APPENDIX A

Publicity for Public Hearing—Advertisements

MT 35: Bigfork North & South

Comments Received During the Public Comment Period and MDT Response

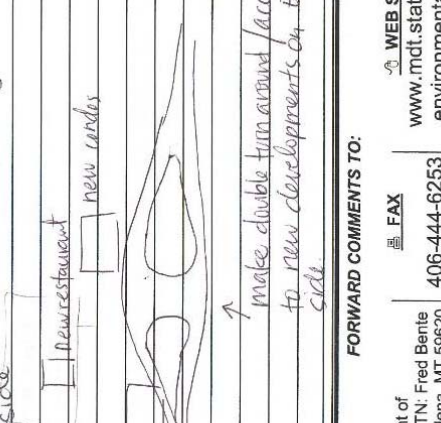
No.	Comment	Response
21	<p>Barbara & Mike Wolstein:</p> <p>MT-35 Bigfork North & South</p> <p>PUBLIC COMMENT FORM</p> <p>Please use the space below to express your comments/concerns about the Preferred Alternative or the Environmental Assessment in general. Comments gathered during the 30-day public comment period will be officially recorded and responded to in the final environmental document.</p> <p>Name: <u>Barbara & Mike Wolstein</u> Date: <u>12 July 2004</u> Address: <u>72, 74, 76 Redgate</u> Phone (if you want a phone call response to comments): <u>957-1112</u> Email (if you want a email response to comments): <u>wolstein@digisys.net</u> Comment refers to document Page Number: <u>Figure B-1</u></p> <ul style="list-style-type: none"> • would grant construction easement but do not want to give any more right-of-way • what type of safety railing would be on top of retaining wall? Do not want liability of someone falling from property • Do not want to lose access to <u>highway</u> roadway • Would like to see staked out where retaining wall will be. Please notify when this ready <u>(near Bob's words by road)</u> • Lot of moving right-of-way to where retaining wall will be • would like to speed limit lowered • Turn lane at Venice Point is good - it will make it safer • where bike path currently crosses could be a problem because of visibility • like bike path behind the pond and like the bike path in general <u>Michelle Wolstein</u> <div style="border: 1px solid black; padding: 5px;"> <p>FORWARD COMMENTS TO:</p> <p>POSTAL Montana Department of Transportation - ATTN: Fred Bente PO Box 201001, Helena, MT 59620</p> <p>FAX 406-444-6253</p> <p>WEB SITE www.mdt.state.mt.us/environmental/eis-ea</p> </div>	<p>Response 21A: The specific right-of-way required for the project will be determined during the final design process. MDT will coordinate with property owners during the final design process. Property acquisition will conform with the Uniform Relocation Assistance and Real Property Acquisition Policies Act of 1970, as amended.</p> <p>Response 21B: Appropriate railing to restrain either vehicles or pedestrians will be provided, including the uphill cut wall locations. Retaining walls located within the clear zone will have railing sufficient to restrain vehicles and pedestrians. Retaining walls located outside the clear zone will have pedestrian railing to prevent falls.</p> <p>Response 21C: Each property owner has rights for access to their property. However, if access is available from other roadways, access is not required to be directly from the property to the highway. During the final design process, an access management plan will be developed by MDT that identifies specific access locations, changes, and configurations. Landowners will continue to be involved in this process as the access management plan is developed.</p> <p>Response 21D: Field staking is done as necessary for project needs.</p> <p>Response 21E: See 21A response.</p> <p>Response 21F: Traffic speed was a dominant issue raised during the stakeholder process. The Executive Summary of the Environmental Assessment describes how this issue is addressed in the Preferred Alternative.</p> <p>The issue of speed was addressed in several different ways: The community of Bigfork approached the Montana Transportation Commission with a request to lower the speed limit. The Montana Transportation Commission decided to lower the speed limit from 45 mph to 35 mph in Bigfork.</p> <p>Several community entry treatments are included in the Preferred Alternative. The purpose of these entry treatments is to alert motorists to slow down as they are entering a more urbanized area. Roundabouts were included in the Preferred Alternative to provide improved consistency of speeds at intersections. All roundabouts will be designed to accommodate heavy trucks.</p>

No.	Comment	Response
21 (cont)		<p>Response 21G: The pathway will be designed to minimize impacts; the specific design of the pathway, including pavement material, exact location, crossings, connections, etc., will be determined during the final design process. Because of concerns voiced about impacts to Daphne Pond, the multi-purpose path will now be located adjacent to the highway, on the west side of Daphne Pond.</p>

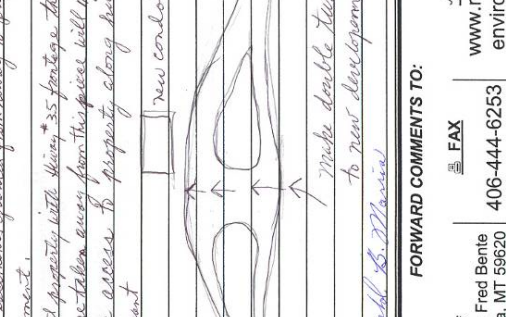
No.	Comment	Response
54	<p>Marty Miller:</p> <p>MT-35 Bigfork North & South</p> <p>PUBLIC COMMENT FORM</p> <p>Please use the space below to express your comments/concerns about the Preferred Alternative or the Environmental Assessment in general. Comments gathered during the 30-day public comment period will be officially recorded and responded to in the final environmental document.</p> <p>Name: <u>Marty Miller</u> Date: _____</p> <p>Address: <u>P.O. Box 213 Lakeside, MT 59922</u></p> <p>Phone (if you want a phone call response to comments): <u>406-844-3113</u></p> <p>Email (if you want an email response to comments): <u>BACKPACK@CENTURYTELE.NET</u></p> <p>Comment refers to document Page Number: _____</p> <ul style="list-style-type: none"> • Community lane entrance needs to be maintained • cannot make it one way. • Access needs to be improved at community lane • Improve the angle of intersections to MT 35 • Additional width of shoulder & path will • Improve visibility for turning into community lane • Opposed to traffic circles (roundabouts) <p style="text-align: right;"><i>Marty Miller</i></p>	<p>Response 54A: Changing Community Lane to a one-way road is not a part of the Preferred Alternative. The exact configuration of intersections and turn lanes will be determined during the final design process.</p> <p>Response 54B: The inclusion of roundabouts was discussed at length with the Bigfork Advisory Committee, who supports them. Roundabouts will be designed to safely accommodate large vehicles/heavy trucks, snowplowing, pedestrian crossings, etc. These design considerations, as well as permanent signage, etc., will be addressed during the final design process. MDT will conduct a public education program about the use of roundabouts before they are implemented.</p>

54A

54B

66-A

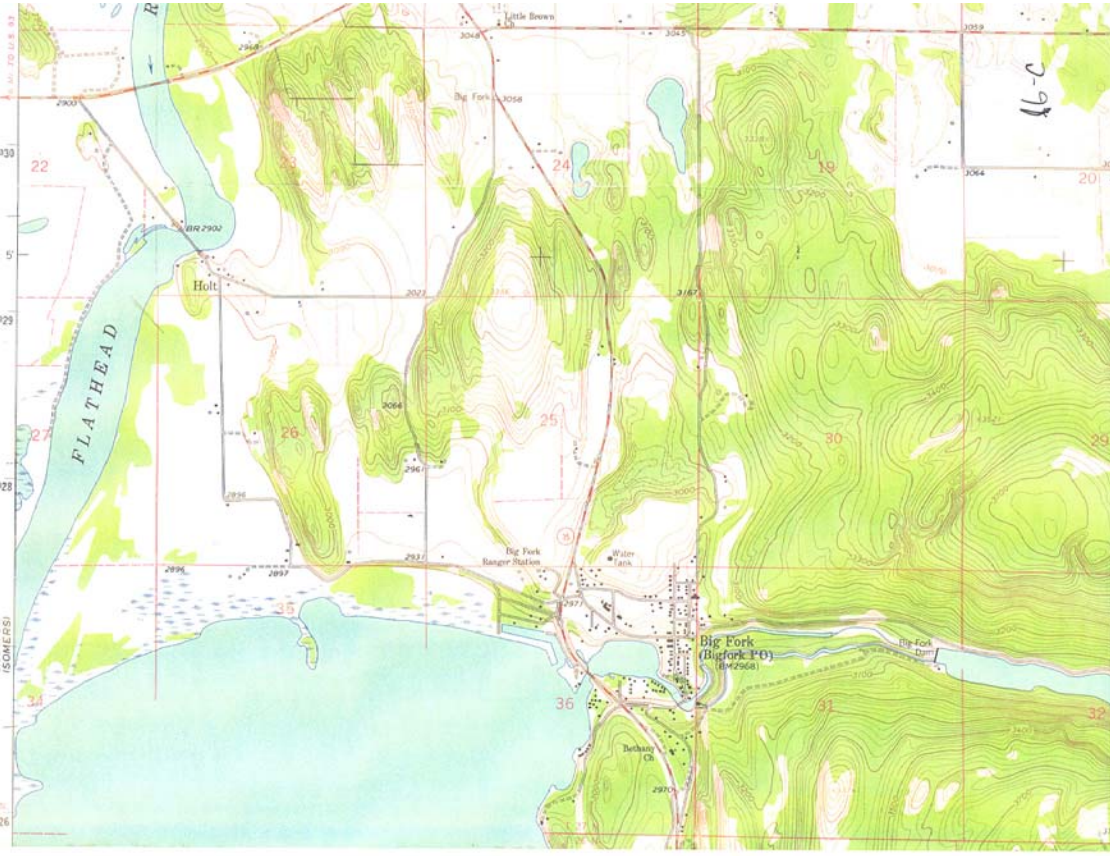
No.	Comment	Response
72	<p>George Darrow:</p> <div style="border: 1px solid black; padding: 5px;"> <p align="center">MT-35 Bigfork North & South</p> <p align="center">PUBLIC COMMENT FORM</p> <p>Please use the space below to express your comments/concerns about the Preferred Alternative or the Environmental Assessment in general. Comments gathered during the 30-day public comment period will be officially recorded and responded to in the final environmental document.</p> <p>Name: <u>George Darrow</u> Date: <u>7/13/14</u></p> <p>Address: _____</p> <p>Phone (if you want a phone call response to comments): _____</p> <p>Email (if you want an email response to comments): _____</p> <p>Comment refers to document Page Number: _____</p> <p><u>Attached maps used for discussion of all new development in Bigfork</u></p> <ul style="list-style-type: none"> <u>Fig B-10 road off ground ave being connected to MT 35</u> <u>is a great idea.</u> <u>look at staggered stop bars into Bay View Dr. off at Holt Drive</u> <u>Wider west bound lane on Holt Drive, short left turn lane</u> <u>Strong endorsement for the bridge design of no center pier.</u> <u>Extend bike/walk path along Grand Ave. to connect to MT-35</u> <p align="right"><i>George Darrow</i></p> </div>	<p>Response 72A: Thank you for your comment. The proposed connection to MT-35 at this location near the Medical Center will require additional business and community input to resolve two exclusive issues. The limited parking at the center is understood as a vital function for patrons visiting there. However, the improved flow of traffic coming and going from high school sporting events off MT-35 could be improved with an approach road here as well. It appears feasible to provide the approach while maintaining parking, but the roadway standard and drainage requirements will need careful consideration. It is quite possible the approach would be limited to right-in/right-out turning movements to prevent creating another congestion point. These issues will be addressed during the final design process.</p> <p>Response 72B: Your suggestion regarding staggered stops will be considered during final design. All traffic lanes will be the MDT standard of 3.6 meters (12 feet). Configuration of turn lanes will be determined during the final design process.</p> <p>Response 72C: Thank you for your comment.</p> <p>Response 72D: The shoulders of the road along the short improved section of Grand Avenue are expected to function as the bike path. The pathway will be designed to minimize impacts; the specific design of the pathway, including pavement material, exact location, crossings, connections, etc., will be determined during the final design process.</p>
